COUNCIL ACTION FORM

REQUEST: INTEGRATED SITE PLAN SUBDIVISION FOR 3619 STANGE ROAD, INCLUDING THE NINETEENTH ADDITION TO NORTHRIDGE HEIGHTS SUBDIVISION PRELIMINARY PLAT AND MAJOR SITE DEVELOPMENT PLAN.

OVERALL SITE LAYOUT

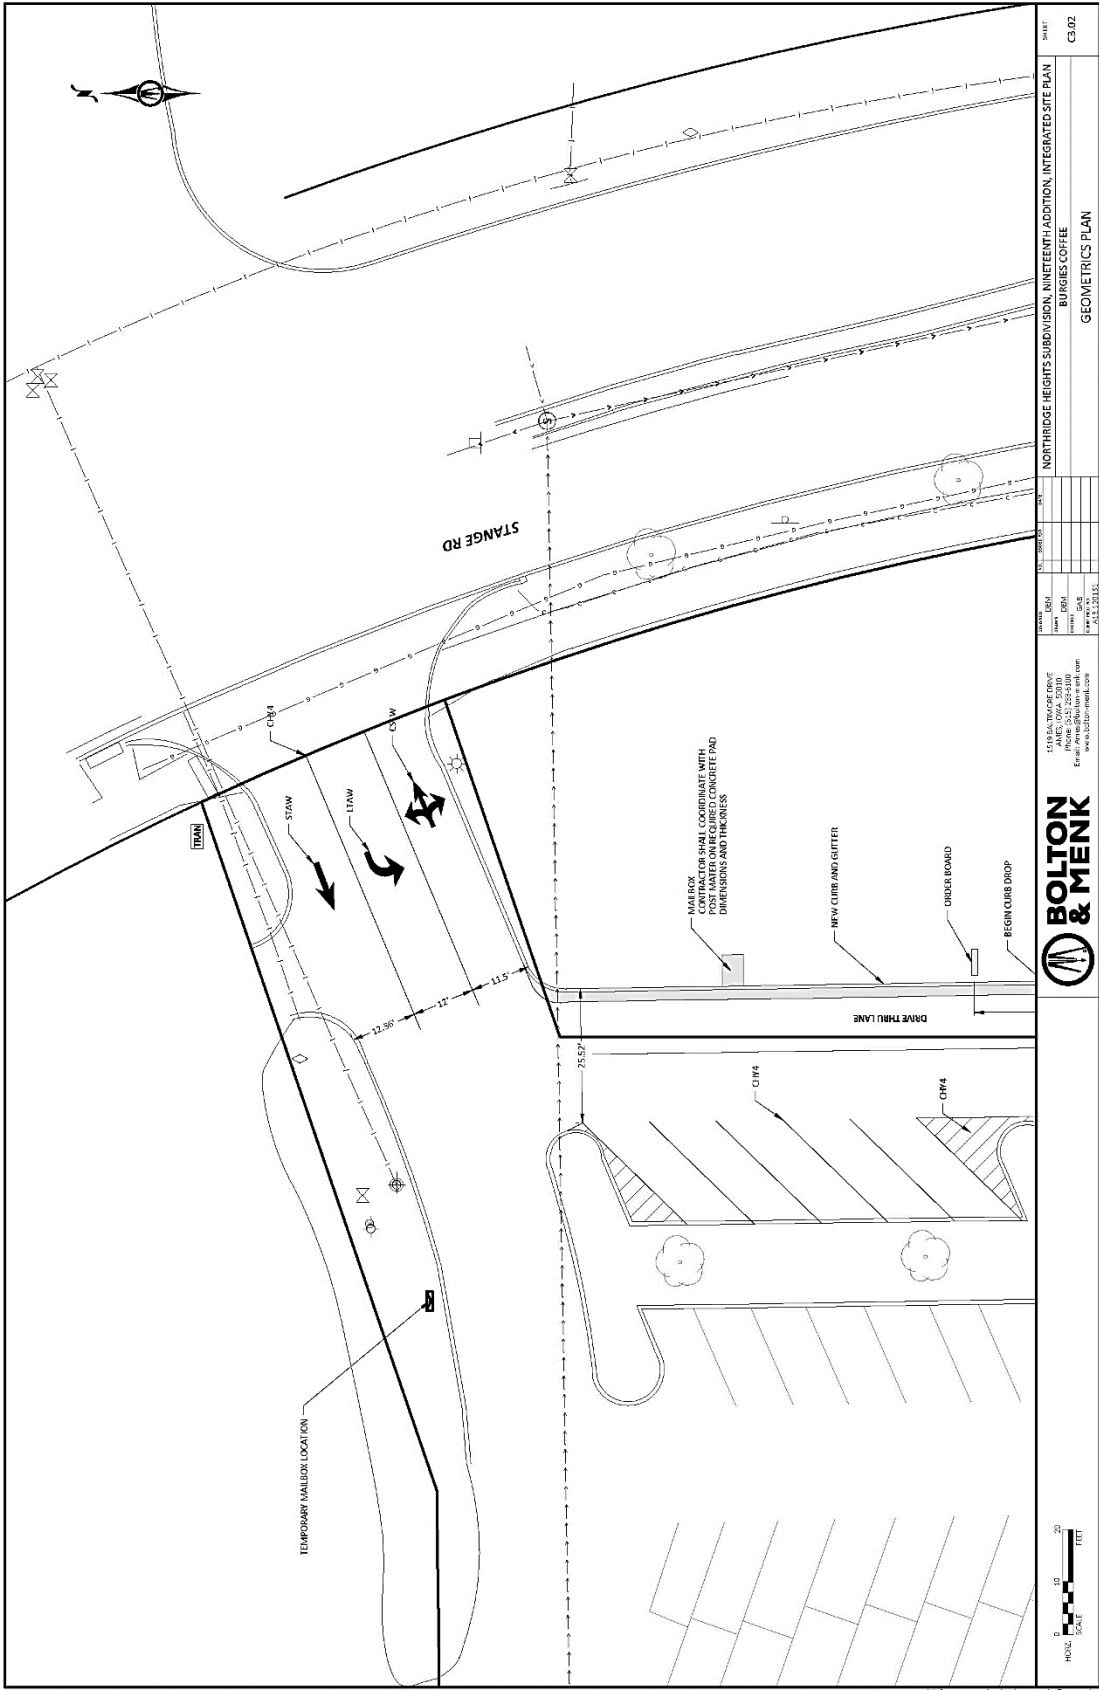
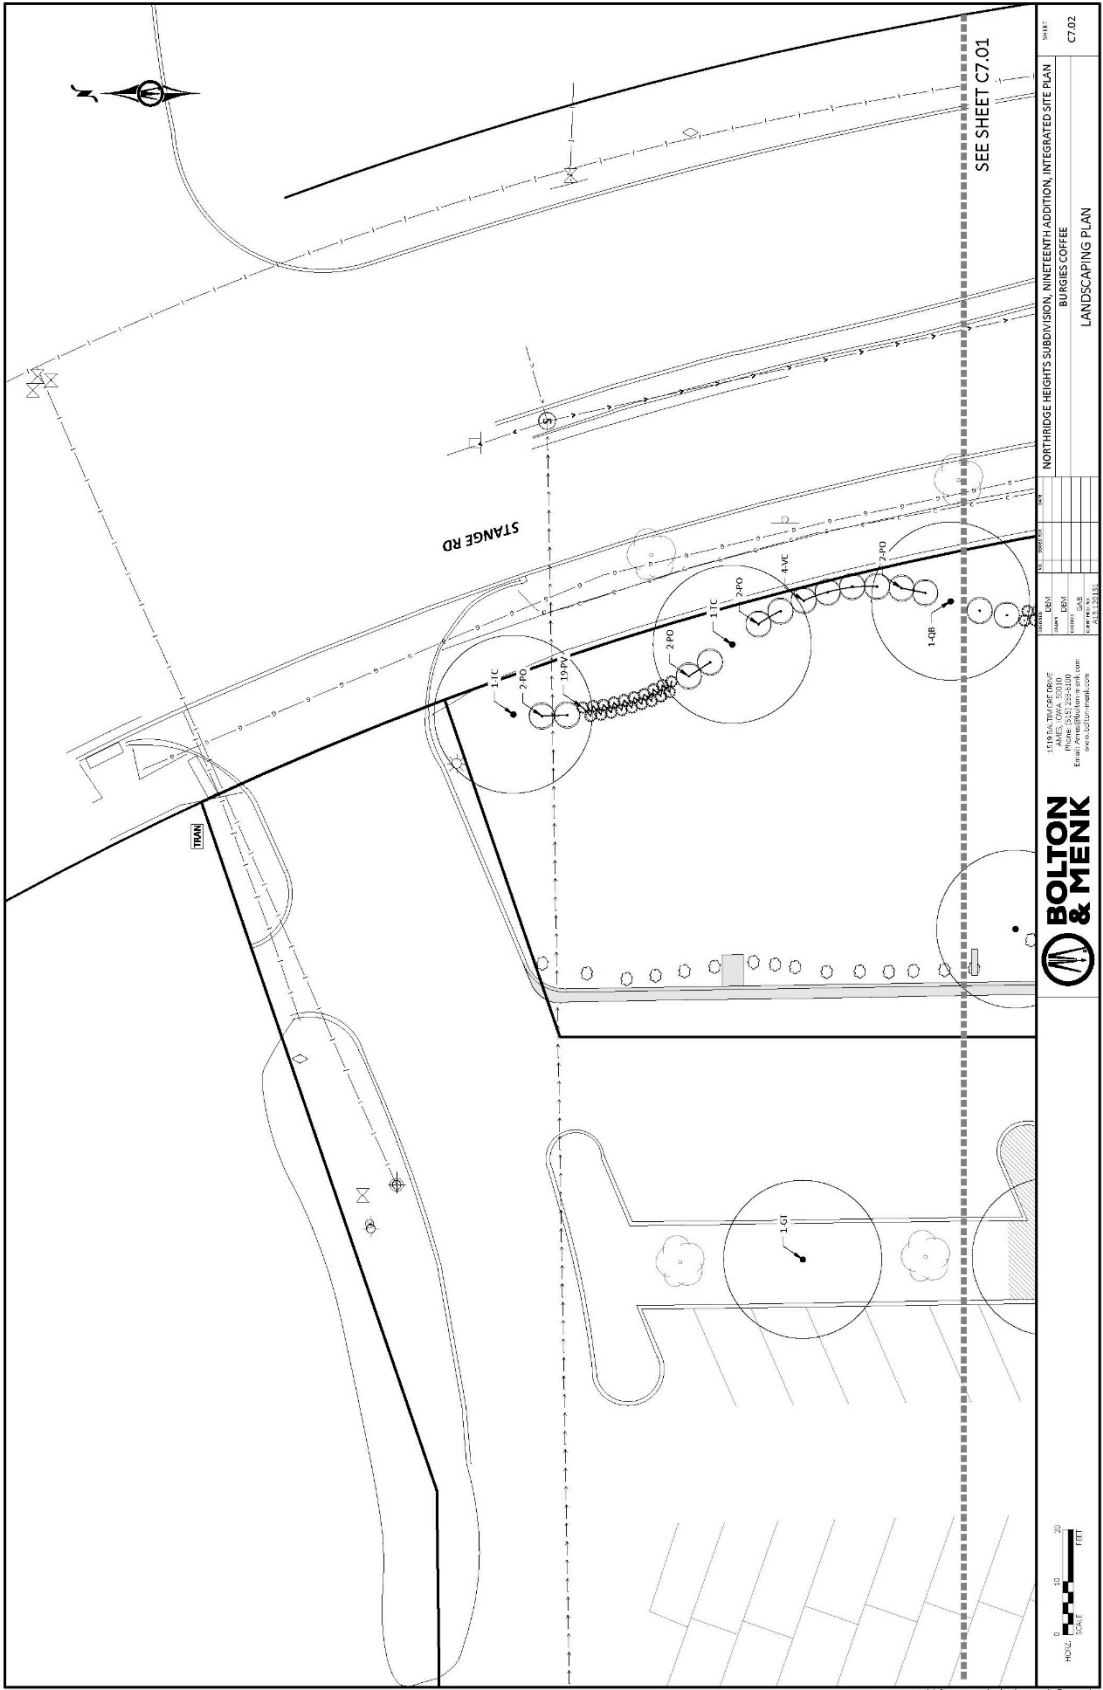
The new Burgie's will have a drive-through window on the west side of the building with enough stacking space, as measured from the menu board to the north driveway entrance, for four cars. Three cars can fit between the menu board and the drive-up window (including the space at the drive-up window). Sec. 29.1303(2) of the Zoning Code requires that stacking lanes "must be designed to provide adequate on-site maneuvering, queueing and circulation area, so that stacking vehicles will neither impede traffic on abutting streets nor interfere with vehicle circulation." The drive-through configuration is the most significant issue for this site plan. Staff has required five stacking spaces, as measured from the menu board, for similar coffee shop drive-throughs for recent projects. To address this concern, the north entrance is being restriped to create a left turn-lane coming off Stange Road that will provide two additional stacking spaces before turning into the drive-through lane.

Access/Traffic. Vehicular access is currently provided to the site from Stange Road. The existing vehicular access points will remain in the same location and configuration. The northern entrance will be restriped to provide a left-turn lane for the parking and drive-through for Burgie’s. An existing ingress / egress easement, providing access to a Banker’s Trust branch, at the north entrance will remain.

The proposed development will continue to take access from Stange Road using the existing vehicular entrances. North-bound automobiles will continue to turn left onto the property from the northern curb cut; south-bound automobiles will continue to turn right at either of the two entrances. The northern entrance will be restriped to create one outbound lane and two inbound lanes: one to go straight towards Fareway and the other to turn left towards Burgie's.

Angled parking is oriented so that vehicles entering from the northern entrance can turn left and go south into the parking spaces or the drive-through. All interior private sidewalks will continue to connect with the public sidewalk system that is already in place.

The Ames Traffic Division reviewed the project and the vehicle access and is satisfied with the configuration and the changes to the interior of the site. Of concern was the truck delivery to the Fareway Grocery, which accesses the property from the northern entrance. Trucks wend their way through the parking to the loading dock on the southwest side of the existing building. The applicant has addressed this concern by proposing to restripe the northern entrance with an incoming lane for heading west towards Fareway, an incoming lane for heading south towards Burgie's Coffee, and an outgoing lane for turning in either direction onto Stange Road.

WEST FAÇADE (FACING FAREWAY)

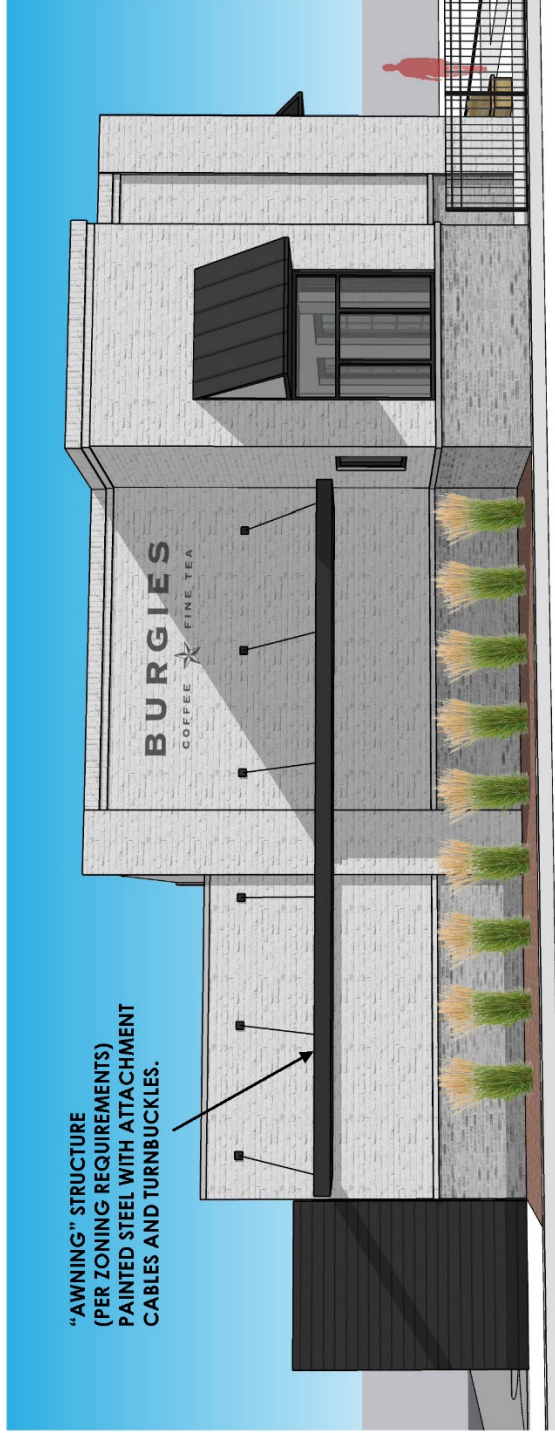
- i. Prior to approval of the MSDP, modify the west façade to bring it into compliance with the architectural standards in Sec. 29.810(4)(d)(ii). *(Applicant has updated the plans to satisfy this condition)*
- ii. Show the location of the proposed electric meter on the outside of the building with corresponding adjustments to the nearby landscaping.
- iii. Compliance with the City's Outdoor Lighting Code.

The west façade facing the parking lot did not comply with the requirements in Sec. 29.810(4)(d)(ii) at the time of the Planning and Zoning Commission review. This regulation requires that the façade be “subdivided and proportioned by openings, such as windows or doors, and/or projecting structures, such as arcades, arbors, or awnings, along no less than forty (40) percent of the length of the façade.” The applicant has added an architectural element that staff has accepted.
